REQUEST FOR INFORMATION **DATE:** April 11, 2017 **NO.:** RFI-516

Project Name: 15051-Webster University Interdisciplinary Science Building Project No.: 15051

Subject: Finishing wall at elevator directory

REQUEST FOR INFORMATION	DATE: March 10, 2017	NO.: RFI-478
--------------------------------	-----------------------------	---------------------

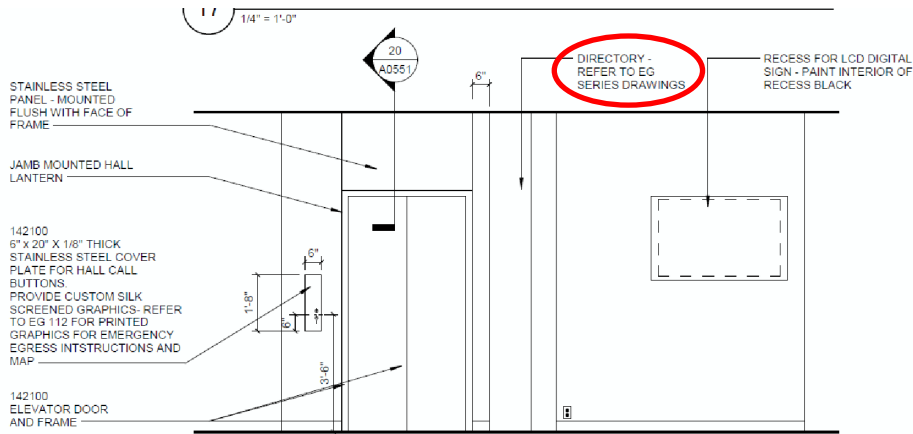
16/A0551 states to refer to the EG drawings for the inset shown for the directory at the elevator. EG111 shows a 24" wide panel with oak veneer mounted to 3/16" mdf backer then mounted to an aluminum metal plate for rigidity. The signage is no longer in Paric's scope so we intend to inset this area 3/4" and the signage can be shimmed out as needed when Webster's signage contractor installs.

Suggestion: Please confirm this will be acceptable.

16 ELEVATOR 1 - TYPICAL ELEVATION
3/8" = 1'-0"

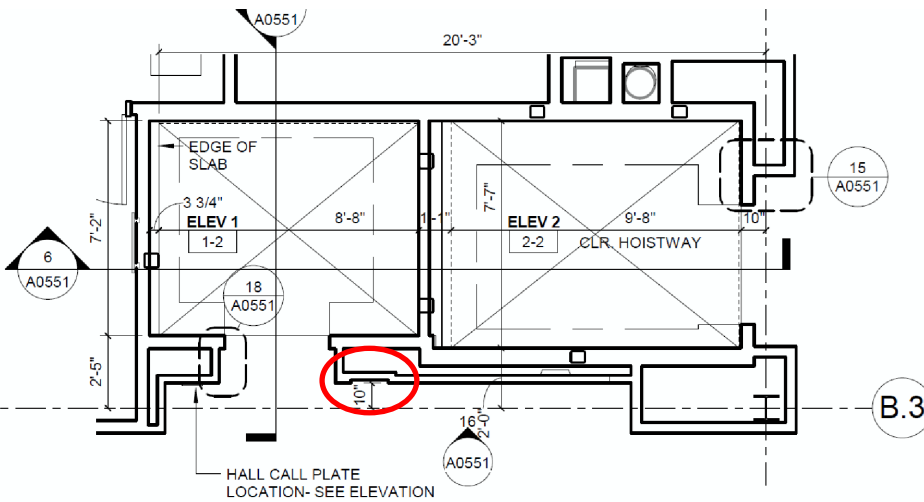
As a followup to RFI 478 please advise if the drywall is to finish up to the directory or if there should be a space between the edge of directory and face of panel.

Provide a finished recess so that the directory signage panel can be installed on z-clips later with gap/clearance around the panel. The signage panel would be field measured before its made.
